Application for Licence Amendment

Licence Number	L4328/1989/10
Licence Holder	MARBL Lithium Operations Pty Ltd
ACN	637 077 608
File Number	APP-0027592
Premises	Wodgina Lithium Project M45/49, M45/50-I, M45/254, M45/353, M45/365-I, M45/381, M45/382, M45/383-I, M45/886, M45/887-I, M45/888, M45/950-I, M45/923-I, M45/924-I, M45/925-I, M45/949, M45/1188-I, M45/1252-I, G45/290, G45/291, G45/321 and L45/443 MARBLE BAR WA 6760 As depicted in Schedule 1 of the Revised Licence
Date of Report	24 June 2025 (FINAL)
Decision	Revised licence granted

Figure 1: Location of Atlas Pit monitoring bores, highlighting proposed radionuclide monitoring bores

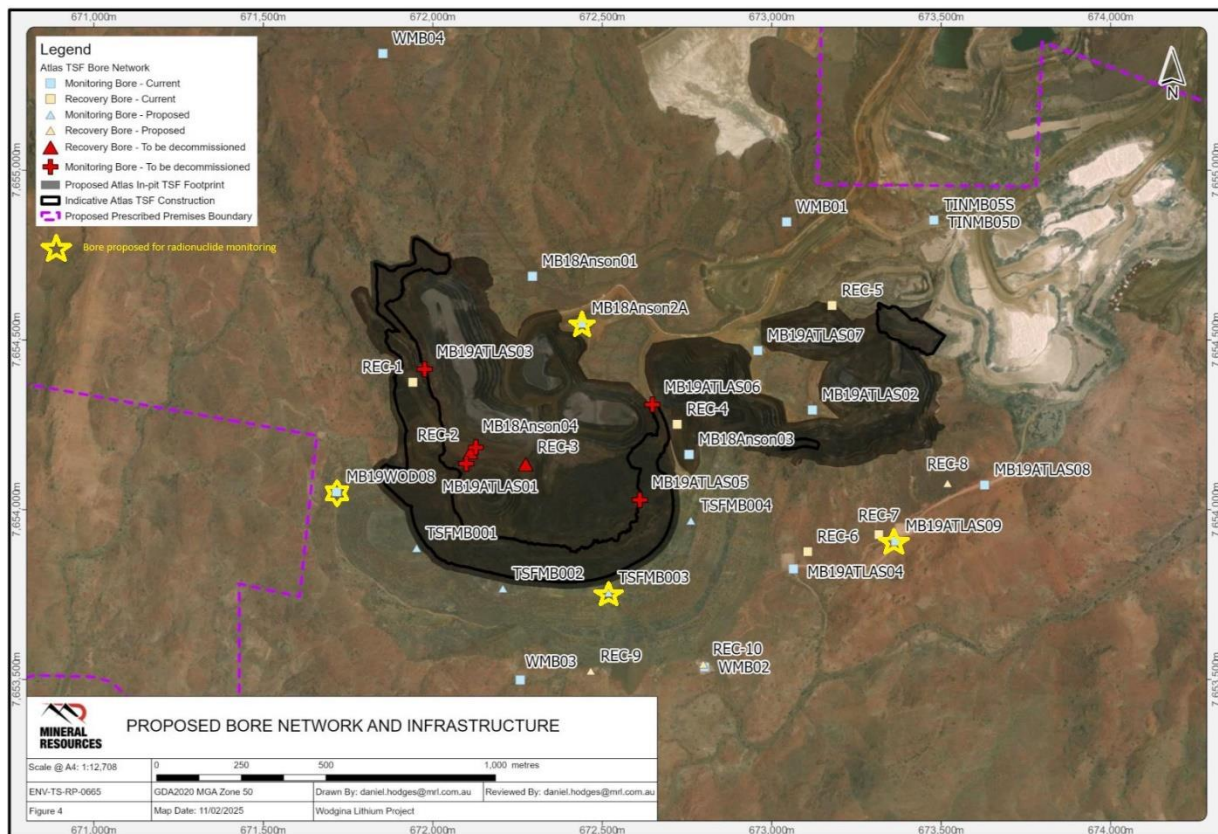
The licence holder has requested some changes to groundwater monitoring for ongoing operations compared with time limited operations. These are considered in Table 2.

Parameter	Requested change	Department's response
All parameters which were required bimonthly during TLO	Change to quarterly	Acceptable. This is consistent with other monitoring requirements on the licence. Bimonthly monitoring during the TLO period has been submitted and provides adequate baseline data.
Standing water level (SWL) and electrical conductivity (EC)	'Daily or monthly' to 'monthly'	Administrative – this is allowable under the W6734 conditions. W6734/2022/1 lists the sampling method as 'data logger'. The licence specifies 'spot sample' for existing groundwater sampling. Either is acceptable so this will be specified on the licence.
Radionuclide analysis (gross-alpha and gross-beta) - During TLO	Only required for TSFMB003, MB19WOD08,	The application states: "Bores have been selected for radionuclide analysis... based on spatial coverage around the Anson A & B pits and targeted aquifers to ensure

these were required for all monitoring bores.	MB19ATLAS09, MB18Anson02A	appropriate monitoring is undertaken around the pits.” Monitoring during Time Limited Operations provided baseline data and showed gross-alpha and gross-beta to be well below the guideline values for livestock drinking water. Given ongoing water level and chemical analysis of all monitoring bores to identify seepage pathways, it is acceptable to reduce the number of bores that are routinely analysed for radionuclides. Figure 1 shows the bores proposed for continued radionuclide monitoring, and Table 3 shows their screen depths. These are considered to provide acceptable spatial spread for radionuclide monitoring at this stage.
-----------------------------------------------	------------------------------	-------------------------------------------------------------------------------------------------------------------------------------------------------------------------------------------------------------------------------------------------------------------------------------------------------------------------------------------------------------------------------------------------------------------------------------------------------------------------------------------------------------------------------------------------------------------------------------------------------------------------------------------------------------------

Figure 2: Location of existing and proposed Reverse Osmosis (RO) plants

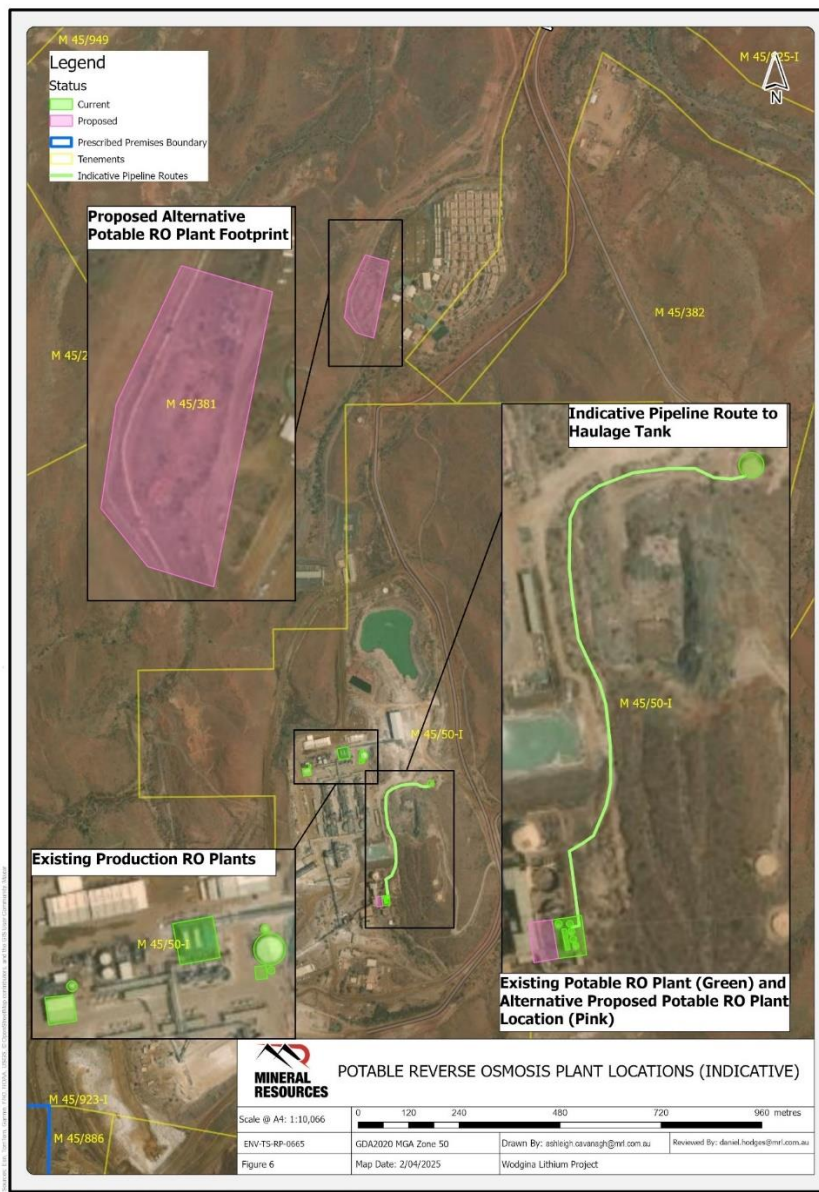
Site 1 is immediately adjacent to the existing small RO plant (discussed below). Site 2 is further north as shown in Figure 2.

If site 1 is selected, brine will be transferred via the existing pipeline shown in Figure 2, to the Haulage Tank to be diluted for dust suppression. If site 2 is selected, the brine tank within that containerised RO plant will be accessed directly by water trucks, and diluted for dust suppression.

Condition	Summary of licence holder's comment	Department's response
Decision Report page 6	Brine from Site 2 will be transferred to a tank within the footprint of the containerised plant area for disposal on Light-vehicle usage roads as dust suppression as approved within the current licence instrument.	Further communication confirmed that the tank within the RO plant will be directly accessed by water trucks and diluted for dust suppression. Decision report updated accordingly and risk assessment finalised.
Decision Report Table 8 / Licence Schedule 1 Figure 2	Replacement Figure 2 provided with updated premises boundary.	Accepted. Updated.

Appendix 2: Standing water level data provided in the 2024 Annual Environmental Report for TSF3 monitoring bores

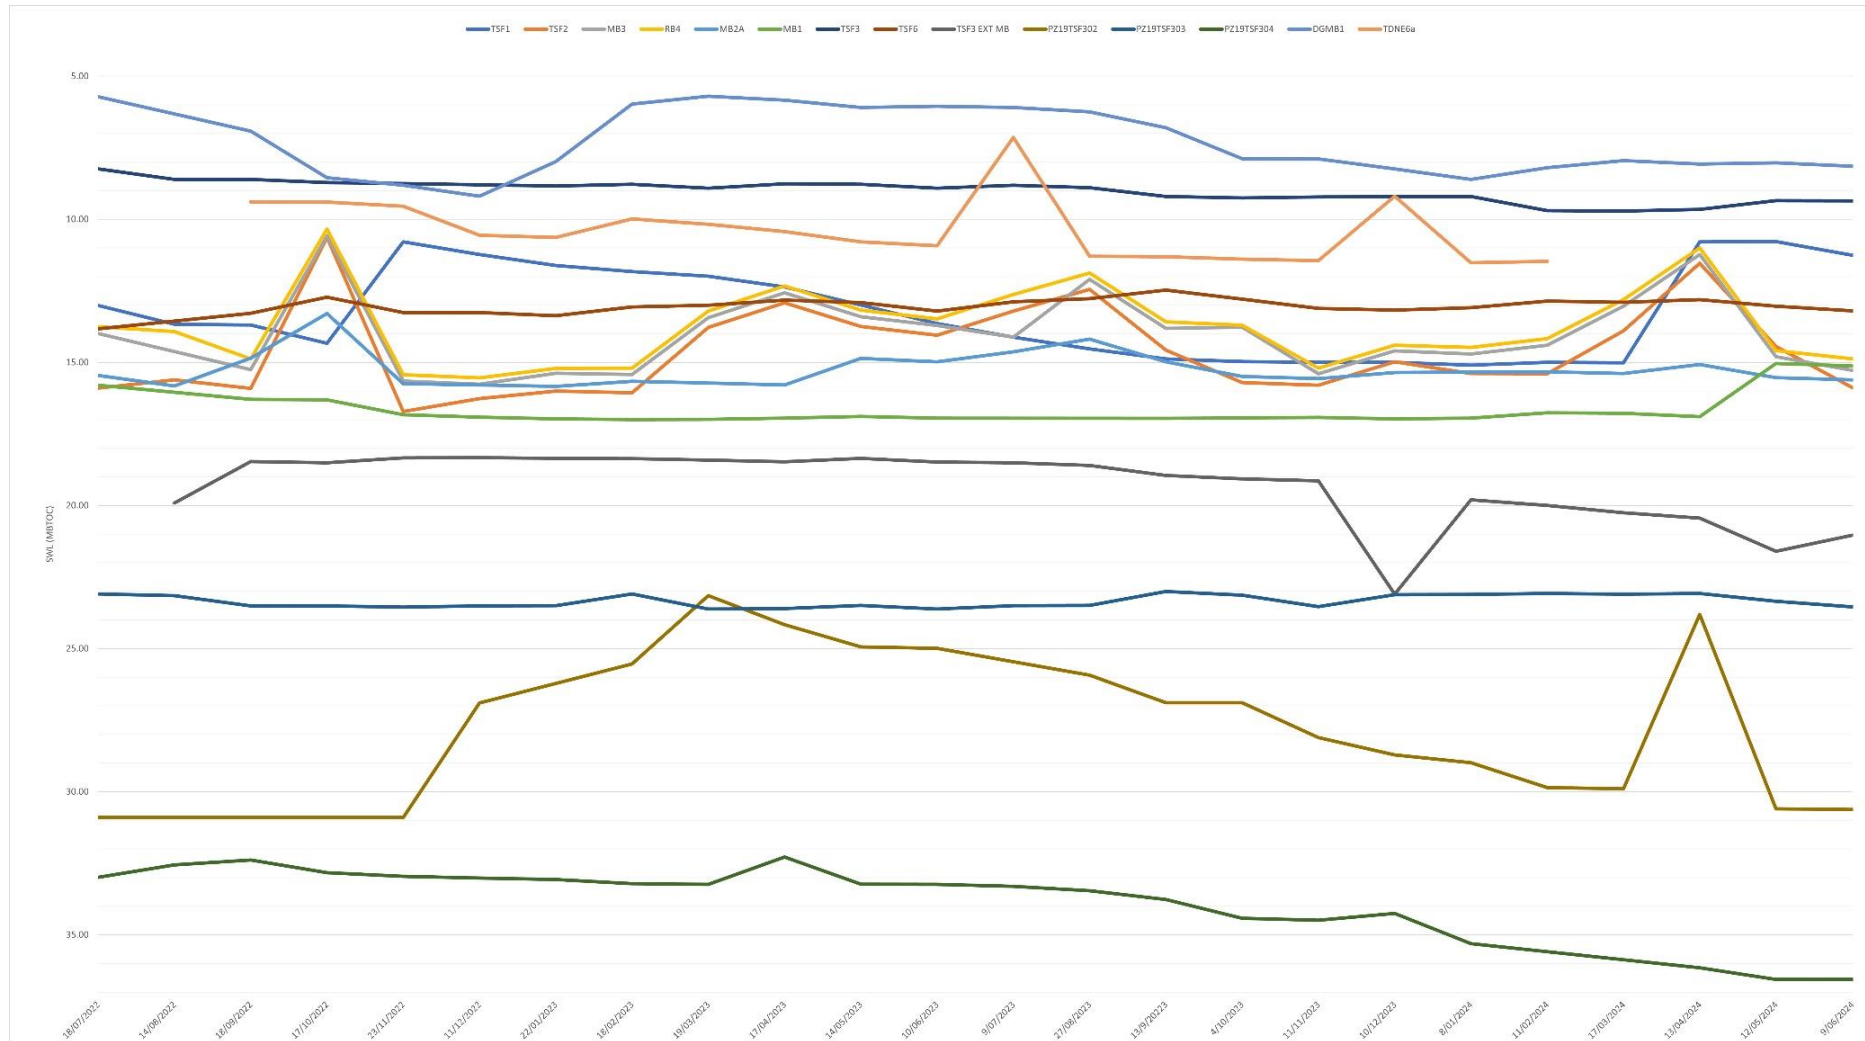
28. Table 12.	The Licence Holder must undertake the monitoring specified in Table 12 according to the specifications in that table.	Removal of items relevant to TSF3E from Table 12.	<p>Accept that decant water and piezometer readings are not required for an inactive facility.</p> <p>The latest annual environmental report for L4328 (July 2023 – June 2024) shows that RB1 and RB4 were dry, therefore these shall be removed from the licence. However seepage was still being recovered by RB2 and RB3 so these should continue to operate and monitoring of recovered seepage is still required at this stage.</p>

29. Table 13.	The Licence Holder must conduct groundwater monitoring programme in accordance with the requirements in Table 13 and record the results of all monitoring activity conducted under that	Removal of monitoring requirements associated with TSF3E considering no further tailings discharges are occurring to the facility.	<p>Agree decant water monitoring is not relevant for an inactive TSF.</p> <p>2024 annual environmental report shows several groundwater bores are dry – removed from licence (RB1, RB4, RB3M, TSF4, TSF5, RB2M, MB2B).</p> <p>2024 annual environmental report shows groundwater levels in most monitoring bores to be steady or declining since August 2023 when deposition to TSF3E ceased (shown in Appendix 2). However seepage recovery is continuing, which is an ongoing seepage management measure. Groundwater monitoring of available bores is still</p>

Condition number	Condition	Proposed Action	DWER response
	programme.		required to monitor the effectiveness of seepage recovery and the impact of cessation.
		<p><u>Licence holder comment on first draft:</u> Licence holder acknowledged a need for some ongoing groundwater monitoring at TSF3, but requested a reduced bore list as mining operations will impinge on several bores. Licence holder noted that deposition at TSF3E ceased over 18 months ago and seepage has much reduced over that time.</p>	<p>The Delegated Officer agrees that seepage recovery volumes have significantly reduced since cessation of deposition into TSF3, and considers that a reduced monitoring program is acceptable. Appendix 4 shows the existing bores and which ones the licence holder proposes to continue monitoring. The Delegated Office considers that this is sufficient. Updated figures are not required but Table 13 is amended as requested.</p>
